•What is the maximum amp draw for the heated DEF lines on the G Van cutaway?

## DIESEL EXHAUST FLUID GUIDELINES FOR UPFITTERS

### WIRE HARNESS

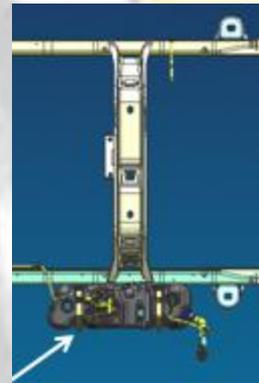
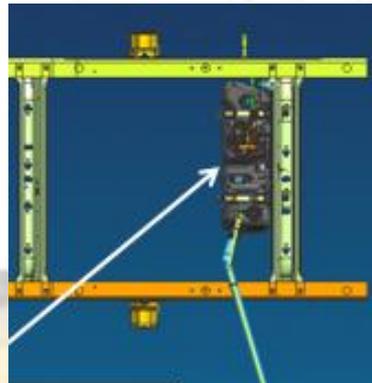
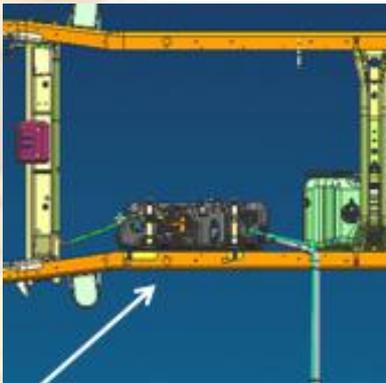
•Can the upfitters shorten or lengthen the DEF supply lines?

•What are the implications if upfitters provide their own DEF heated supply lines and unique lengths?

- This line is heated, do not cut or adjust length. There is a wire coil along the entire length including the connectors to maintain DEF fluid delivery at all temperatures.
- There are vehicle calibrations that are specific to the line length in your vehicle as delivered (e.g. line purge at ignition off, heater performance diagnostics)
- In the case where the tank is moved closer to the dosing module, carefully coil any extra line and secure to maintain the “as shipped” heated line length.

Use GM clip part #25952656, Available through Service after SORP

- Do not change the wire harnesses on the DEF tank. It has a specific wire coating that prevents urea from “wicking” through the harness in the event of a urea spill.
- Carefully coil any extra line and secure.

2010 OM, Water in Fuel

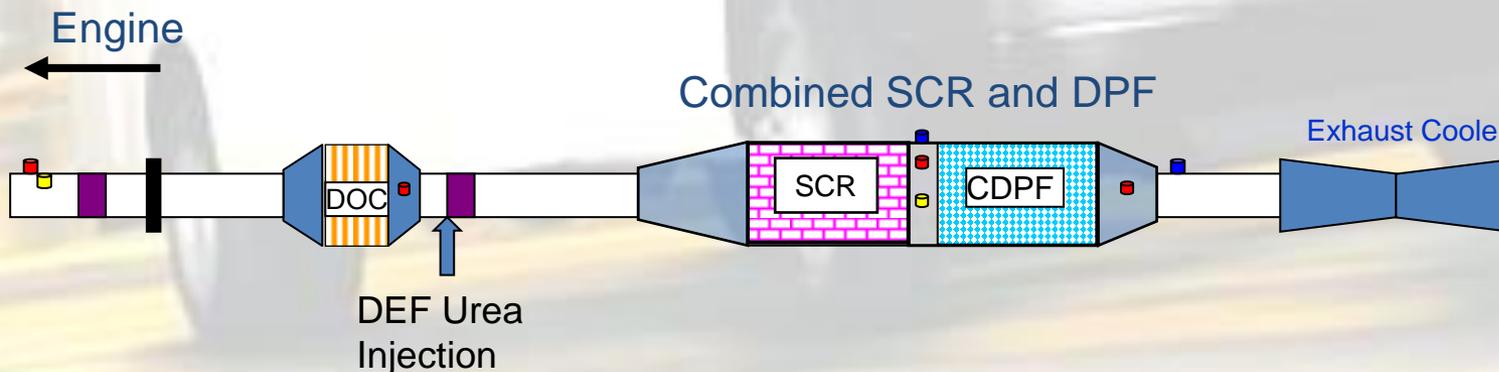
•We need to understand if our hardware and messaging to alert drivers for water in diesel fuel and fuel filter water is effective on alerting drivers that DEF fluid has inadvertently been added to the fuel tank. We also need to determine what we will communicate to customers in the event DEF fluid is added to the fuel tank (i.e drain the water in the fuel filter, replace the fuel filter element, return the van to the dealer for service etc.). Slides #5

If a customer accidentally adds DEF into the fuel tank by mistake, the WIF sensor/algorithm will respond, and a WIF message will trigger (Similar to having water in the tank). In this case, the Owner's Manual info for WIF also applies to DEF:

The owner's manual covers this topic very thoroughly, and at most, the only addition we might consider would be to expand the above verbiage to "water or DEF fluid".

Low Sulfur Diesel Fuel Only Tag: (reference)

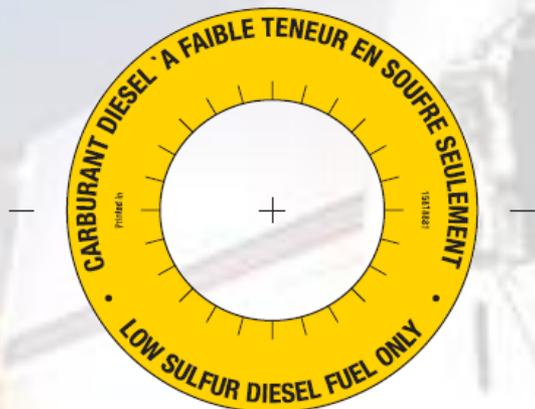
•Can GM provide a hang tag for diesel cargo van to over communicate to the customer that the van is equipped with a DEF system and be sure to only add DEF fluid to the DEF fill pipe with the blue cap. G Van utilized a similar (over communication) approach for the 2006 MY when the diesel was introduced to remind the customers this was a van equipped with diesel engine and required diesel fuel to help the fleet and van operators inadvertently add gasoline to the tank. Slide #6

• Hang Tag on DEF fill (Full Body Applications) as additional communication. (first year of production only.)

Update tag verbiage to:  
"Diesel Exhaust Fluid Only"
